FORM APPROVED
OMB NO. 1004-0137
Expires: January 31, 2018**SUNDRY NOTICES AND REPORTS ON WELLS**
Do not use this form for proposals to drill or re-enter an abandoned well. Use form 3160-3 (APD) for such proposals.5. Lease Serial No.
NMMN030453

SUBMIT IN TRIPLICATE - Other instructions on page 27. If Unit or CA/Agreement, Name and/or No.
891000303X1. Type of Well
☒ Oil Well ☐ Gas Well ☐ Other8. Well Name and No.
POKER LAKE UNIT 13 DTD 905H2. Name of Operator
XTO PERMIAN OPERATING LLC
Contact: KELLY KARDOS
E-Mail: kelly_kardos@xtoenergy.com9. API Well No.
30-015-46106-00-X13a. Address
6401 HOLIDAY HILL ROAD BLDG 5
MIDLAND, TX 797073b. Phone No. (include area code)
Ph: 432-620-437410. Field and Pool or Exploratory Area
PURPLE SAGE-WOLFCAMP (GAS)

XTO Permian Operating, LLC requests permission to make the following changes to the original APD:

XTO Energy Inc.
PLU 13 Dog Town Draw 905H
Projected TD: 21510' MD / 11423' TVD
SHL: 477' FNL & 2205' FEL , Section 24, T24S, R30E
BHL: 200' FSL & 2169' FEL , Section 25, T24S, R30E
Eddy County, NM

WELL LOCATION AND ACREAGE DEDICATION PLAT

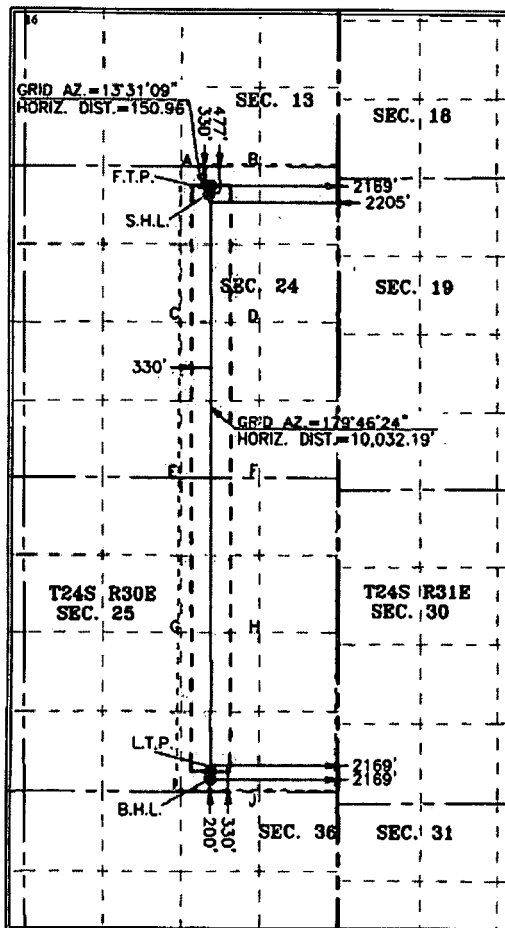
UL or lot no.	Section	Township	Range	Lot Idn	Feet from the	North/South line	Feet from the	East/West line	County
O	25	24 S	30 E		200	SOUTH	2,169	EAST	EDDY
